7. INSTRUMENTATION AND CONTROLS**US-APWR Design Control Document****7.8 Diverse Instrumentation and Control Systems**

MIC-04-07
-00001

Table 7.8-11 Safe State in State-Based Priority Logic

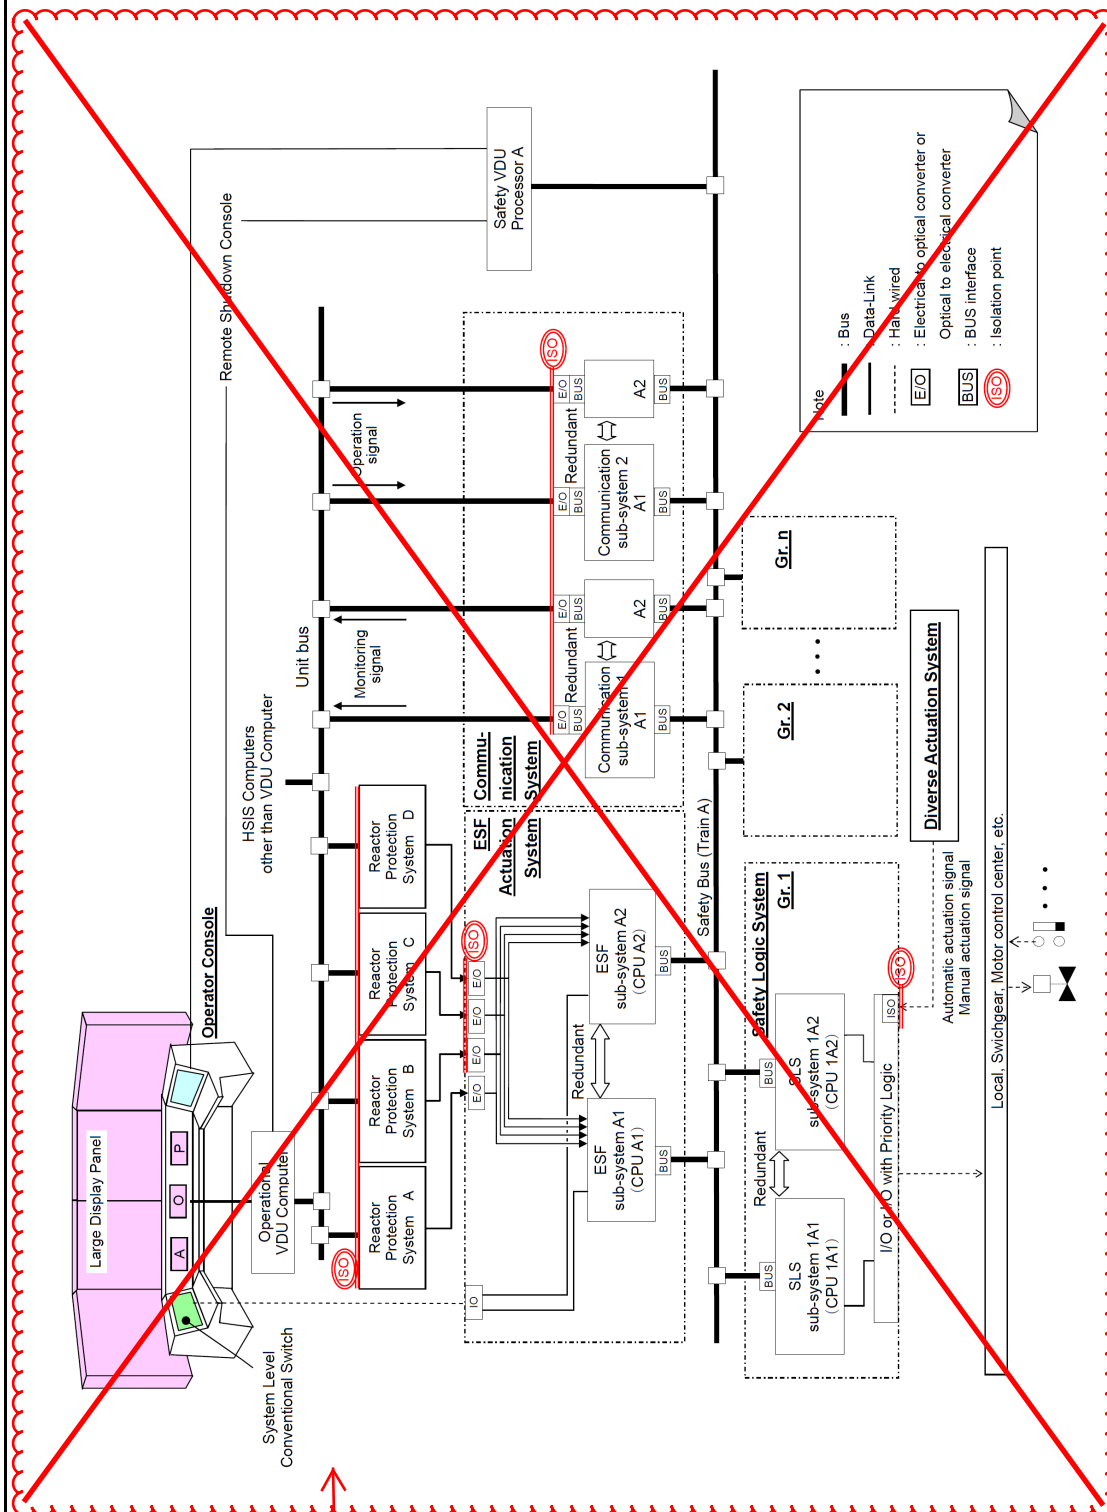
Add Table 7.8-11.

Component	Required Position	Safe State in Priority Logic	Remarks
Reactor Trip	Trip	Trip	DAS signal has no interface to PSMS.
Turbine Trip Solenoid Valves	Open	Open	PSMS and DAS have only open signal.
EFW Pumps	Start	Start	
Safety Injection Pump	Start	Start	
Safety Depressurization Valve	Open/ Closed	Open	Safe state is determined as the position opposite to the most frequent position of operation. ^{*1}
Main Steam Depressurization Valve	Open/ Closed	Open	Safe state is determined as the position opposite to the the most frequent position of operation. ^{*1}
SG Blowdown Isolation Valve	Closed	Close	
MFW Regulation Valve	Closed	Close	
EFW Control Valve	Open/ Closed	Close	Safe state is determined as the position opposite to the the most frequent position of operation. ^{*1}
CV Isolation Valves	Closed	Close	
Main Steam Line Isolation Valves	Closed	Close

Figure 7.3-1 Configuration of Engineered Safety Features Actuation System and Safety Logic System

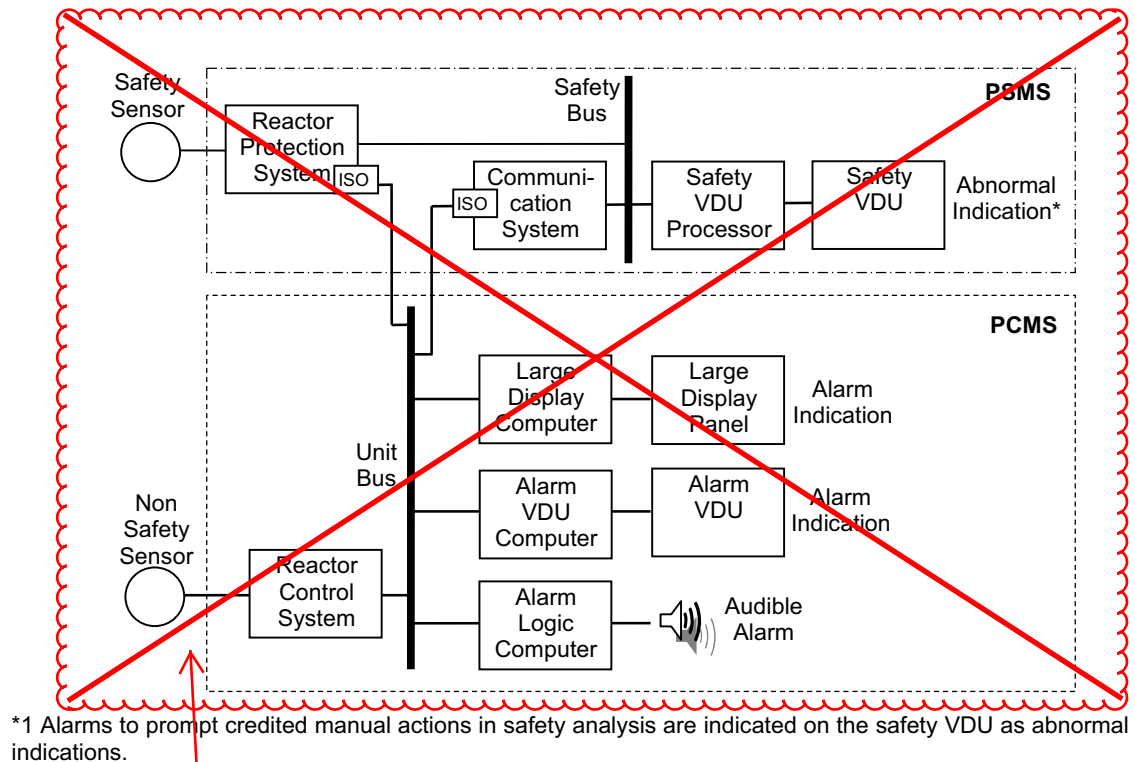
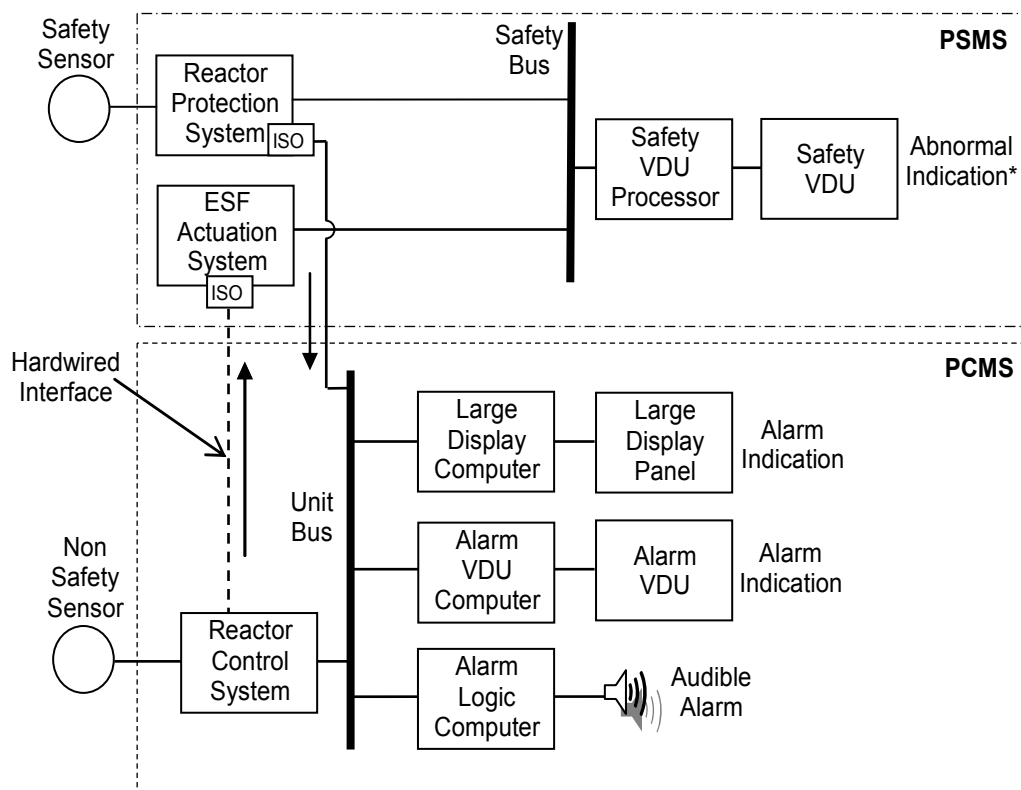
Change this figure as shown in the next page.

Figure 4.1-5 Configurations of the ESFAS, SLS, and Safety-Related HSI

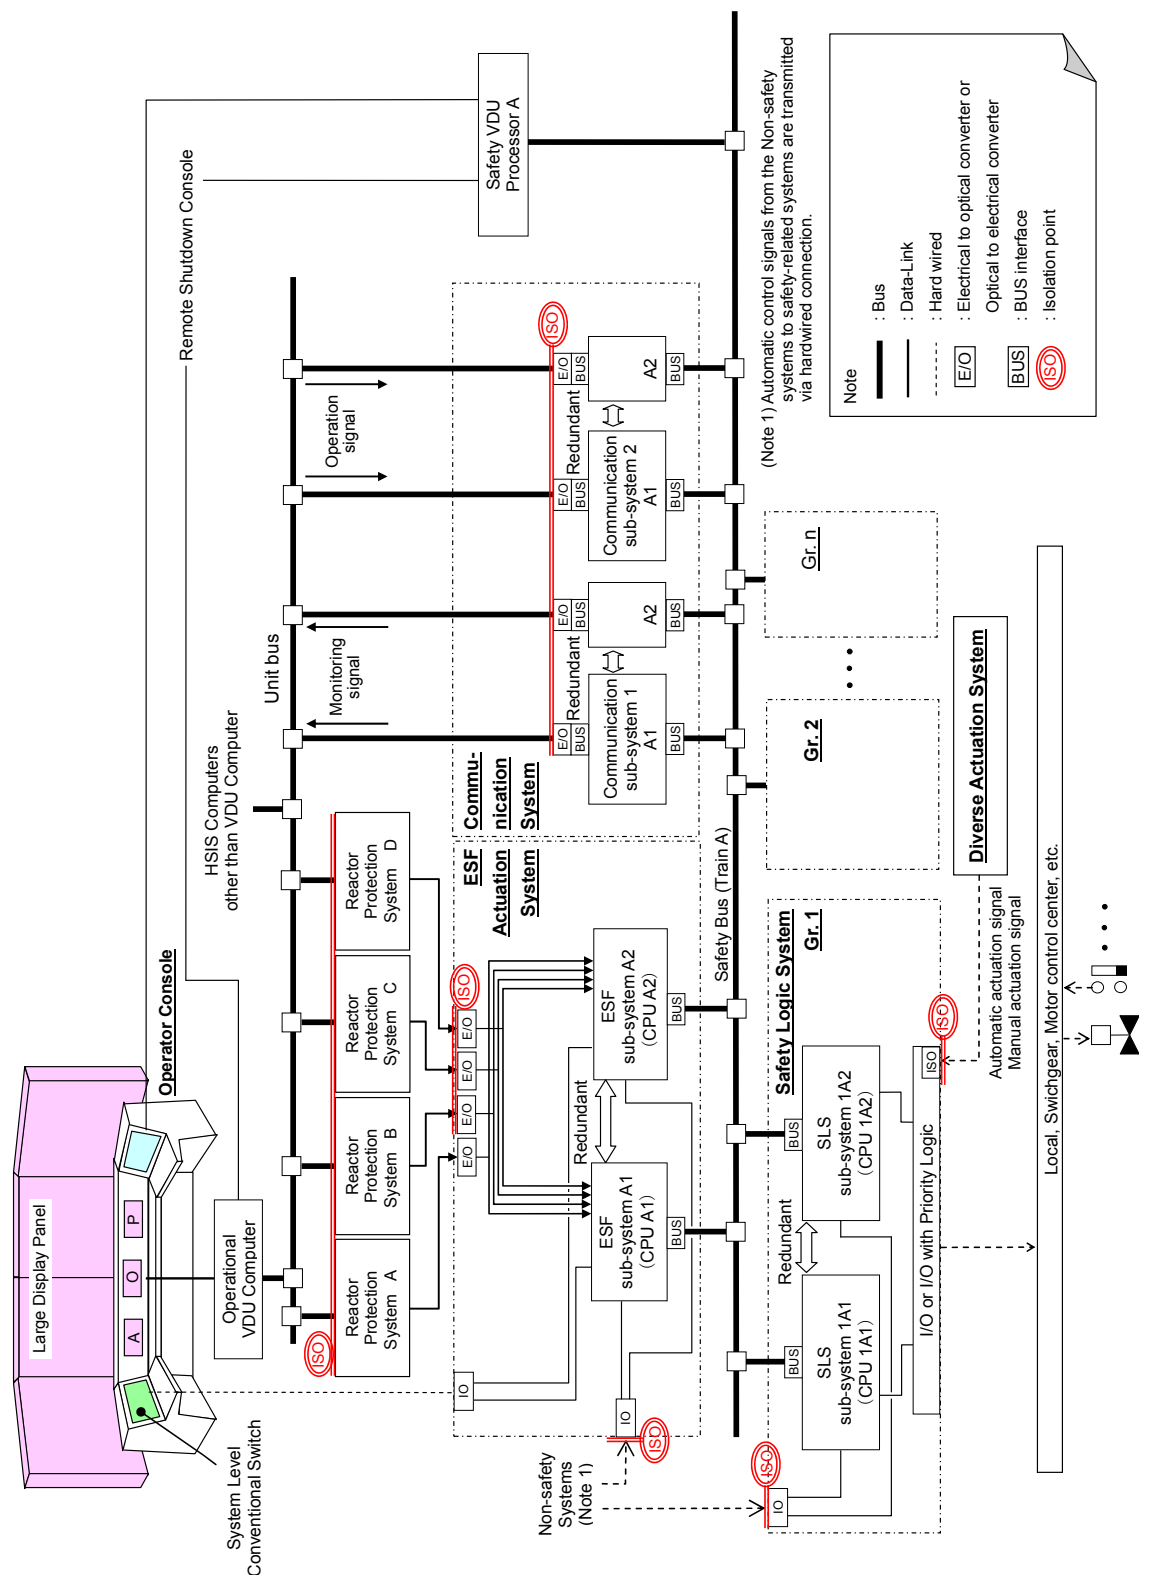
Change this figure as shown in the next page.
